Environmental Comments:

Traffic Comments:

2. Site development plan sheet 12

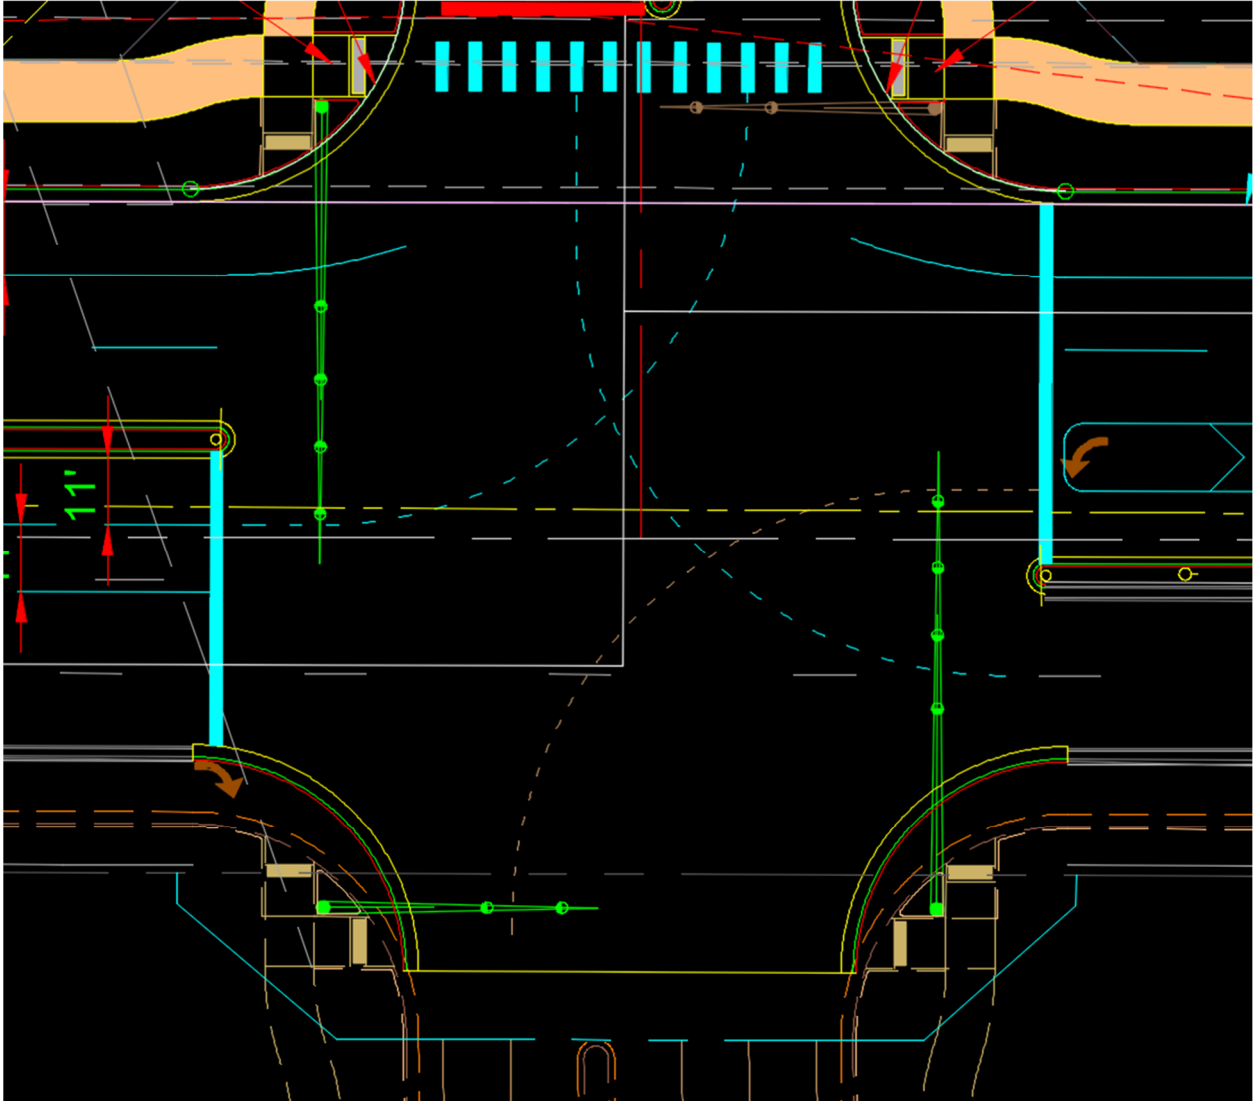
Median width is unclear. Generally, you need a 6' envelope (1 WB inside shoulder, 4 hardscape width, 1 EB inside shoulder). Is that being achieved?

The WB to SB le turn lane is labelled as 11 wide, but that may include the theoretical 1 shoulder/gutter, making it a 10 lane. How far is traffic from the edge of any median posted signs?

Response: The median width is 6' as described in your comment.

Response: The widths provided are from stripe to edge of pavement. The turn lane has 11' of asphalt. The signs post will be 3.5-feet from the edge of pavement.
